Addendum #2

Attn: Estimator	Date: November 26, 2024
From: Lisa Donahue, Project Administrator	Pages: 25 (including cover page)
Re: Bullock Creek School District 2024 Bond Series 1	Project: 2025 Summer Projects HS/MS/Elem/Pine River/Floyd and Maintenance Building
CC:	Proj. #: A24907

ADDENDUM #2

Project: No. 24-120 2023 Bond – Series 1 2025 Improvements

'C' WING PARTIAL MECHANICAL FLOOR PLAN
1/8" = 1'-0" X01

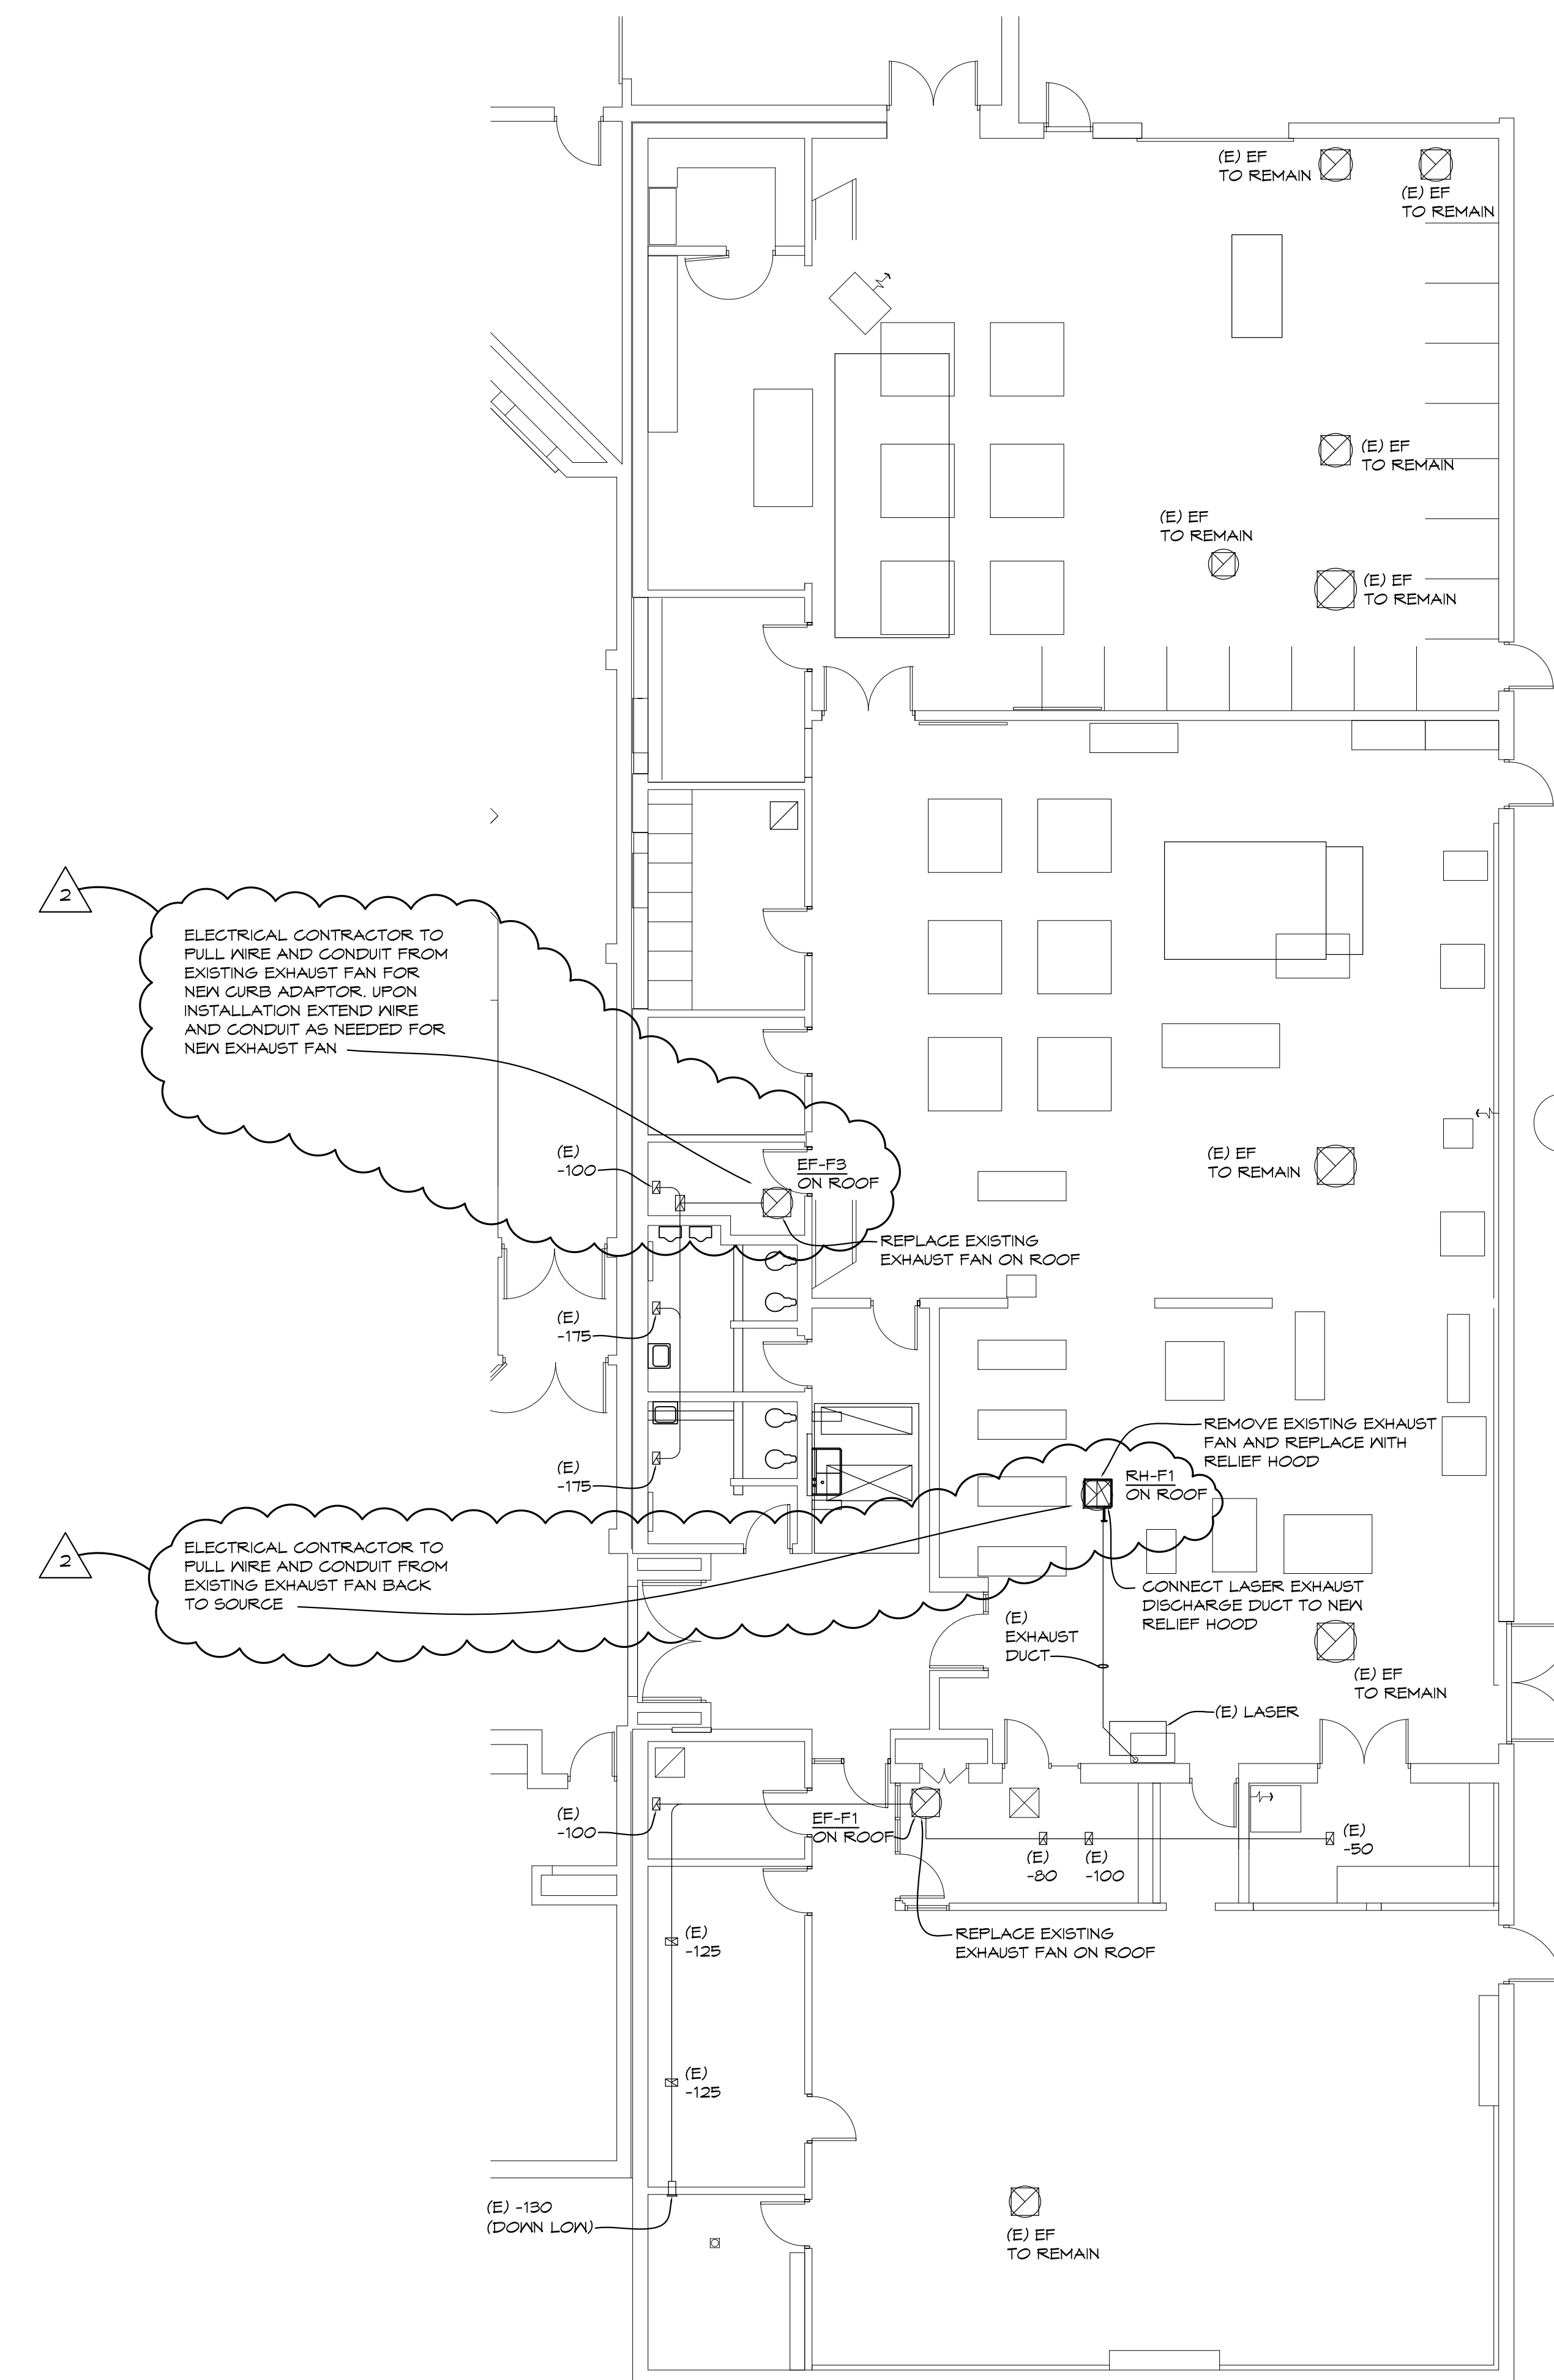
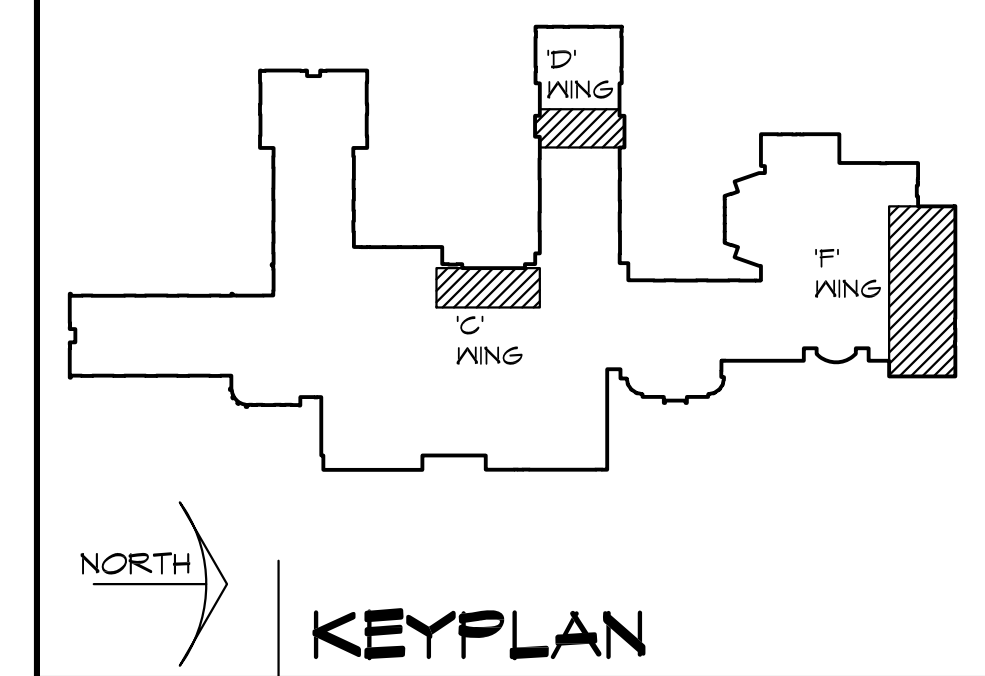
- Item #E1: Revise Sheet A-M102 as follows:
- a. Revise drawing number to be "A-ME102".
 - b. At exhaust fan replacement locations, pull wire and conduit from existing exhaust fan for new installation and extend wire and conduit as needed.
